Access Compliance Report

Public Rights-of-Way

Intersection ID: 10011755	Main Street: DAWN_CR	Cross Street: N/A	Location: E
ADA ID: D8190E7C6B13	Ramp Type: Combination2	Initial Pass/Fail: Fail	Overall Compliance: No
		Severity Score: 12.5

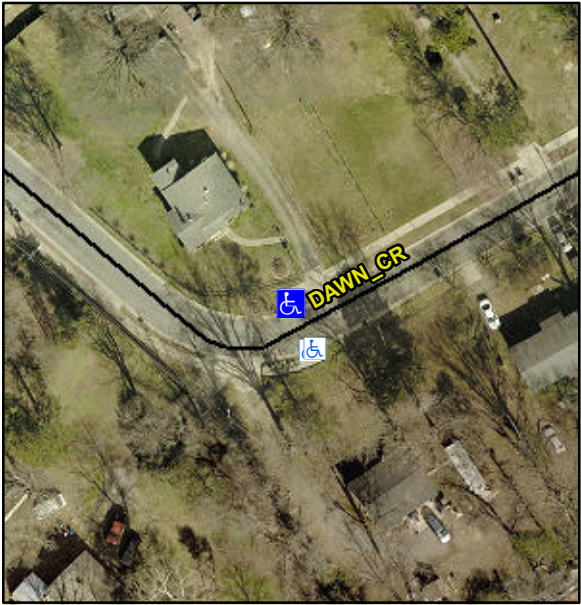
DAMAGED DWS, LT RP < 5%

Not Found, R304.5.3

Remove & Replace Entire Ramp.
